# Ocotillo Estates Unit Six

City Plan Commission — September 25, 2025 **(REVISED)**

<b>CASE NUMBER/TYPE:</b>	<b>SUSU25-00081 – Major Preliminary</b>
<b>CASE MANAGER:</b>	Saul Fontes, (915) 212-1606, <a href="mailto:FontesSA@elpasotexas.gov">FontesSA@elpasotexas.gov</a>
<b>PROPERTY OWNER:</b>	EP Park Hills II, Ltd
<b>REPRESENTATIVE:</b>	Conde, Inc.
<b>LOCATION:</b>	East of Redd Rd. and South of Transmountain Rd. (District 1)
<b>PROPERTY AREA:</b>	21.10 acres
<b>VESTED RIGHTS STATUS:</b>	Not Vested
<b>PARK FEES:</b>	Park Fees Not Required
<b>EXCEPTIONS/MODIFICATIONS:</b>	Yes, see following section
<b>ZONING DISTRICT(S):</b>	PMD (Planned Mountain Development)

# **ATTACHMENT 4**

## **ATTACHMENT 2**

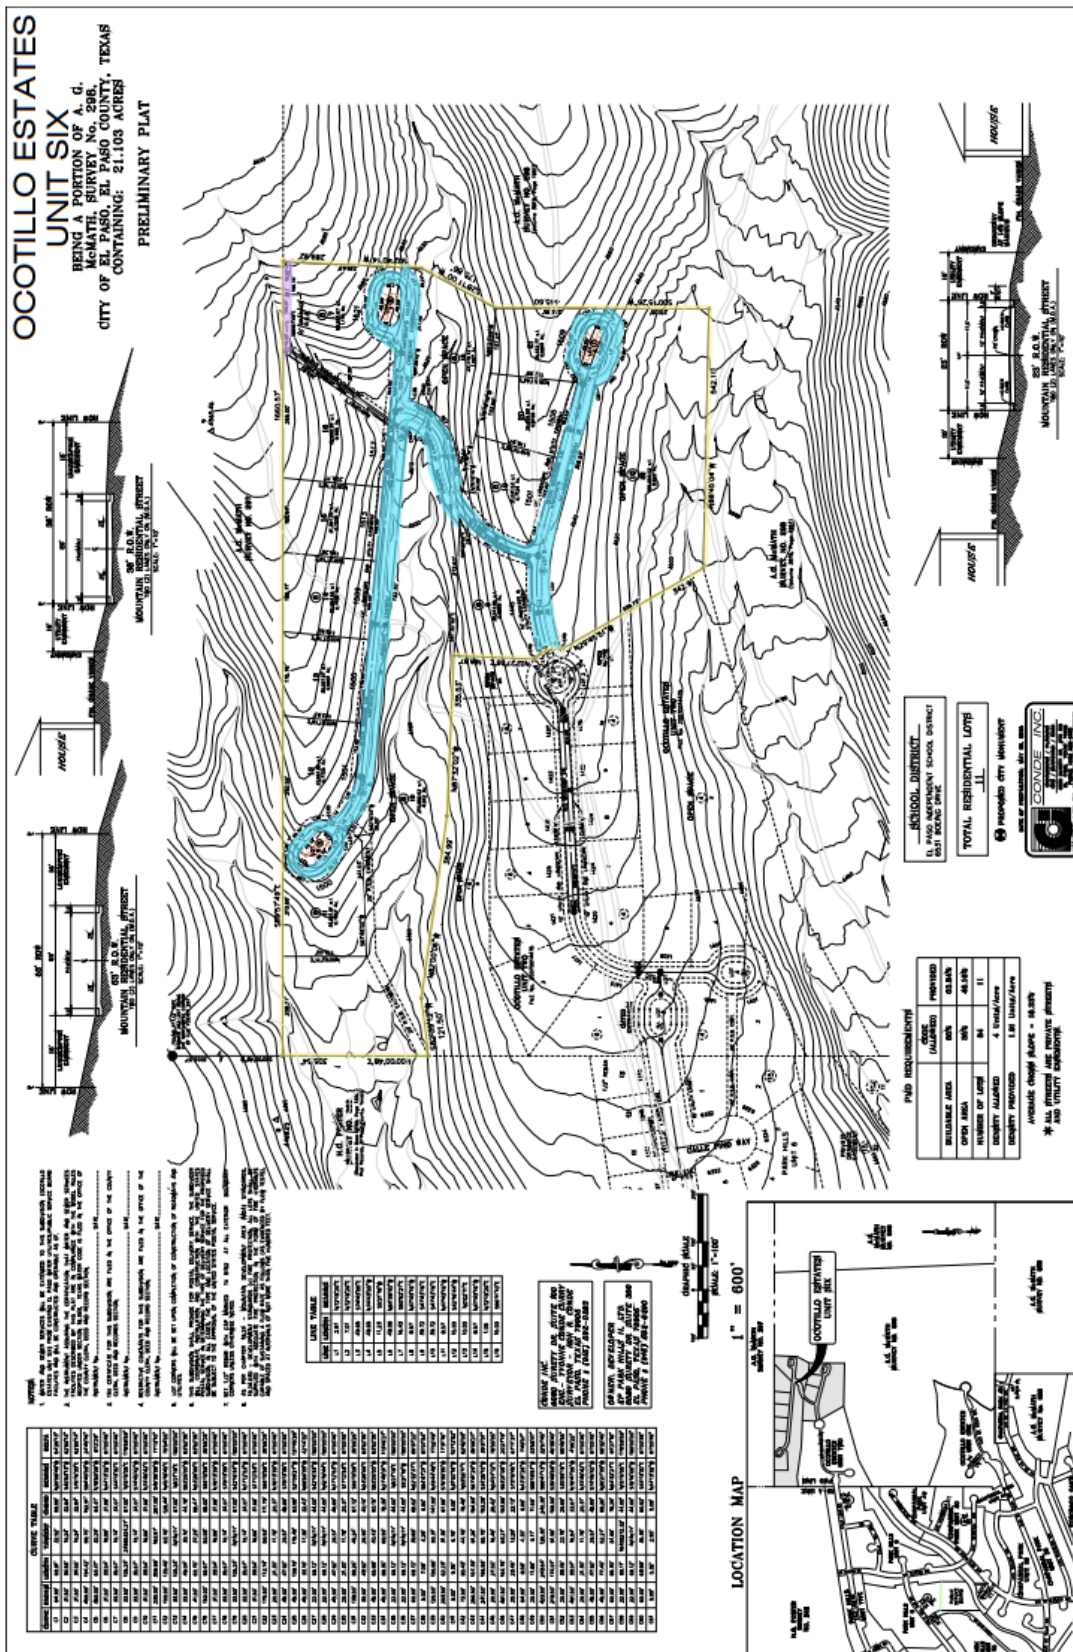
1. Submit to the Planning & Inspections Department – Planning Division the following prior to recording of the subdivision:
  - a. Current certificate tax certificate(s)
  - b. Current proof of ownership.
  - c. Release of access document, if applicable.
  - d. Set of restrictive covenants, if applicable.
2. Label the use for Lot 8, Block 9; Lot 7, Block; and Lot 6, Block 7.
3. Update Block numbers per CAD comments.

1. Print-out of the mathematical closure is ok.
2. Delineate percent buildable area for each lot, if different than lot limits.
3. The property area will be in the Flood zone according to the (preliminary) future FEMA maps. Meaning; that according to current maps from FEMA, the property is not in the flood zone area, but the property will be in the flood zone area in the future when new maps become effective. It is recommended to build 1 foot above the preliminary BFE for the affected lots.
4. Vertical cut and fill of existing grade shall not exceed 15' at time of grading (Municipal Code 19.24.030.D.2).

2. Please provide a note on the plat stating who will be maintaining the proposed Open Space. The Parks & Recreation Department will not accept the open space for maintenance.

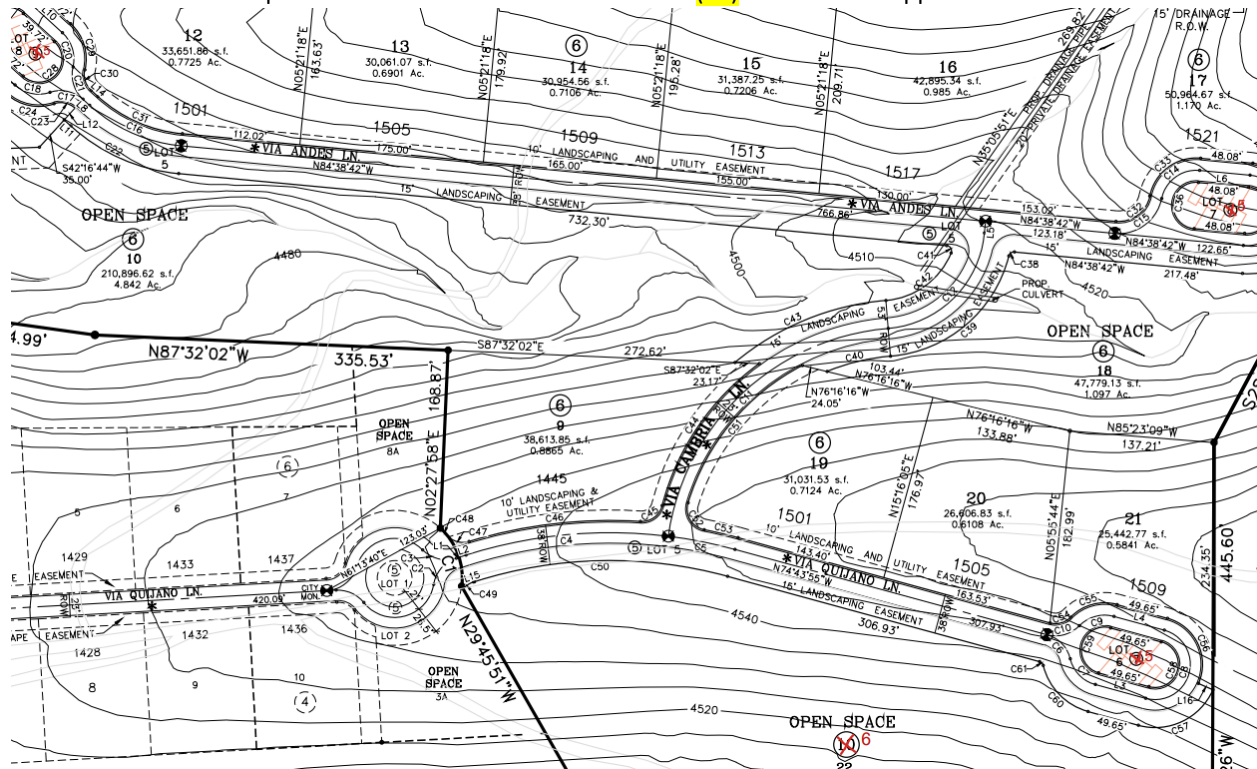
Please see attached map for corrections for Ocotillo Estates #3 (#6) from Central Appraisal.
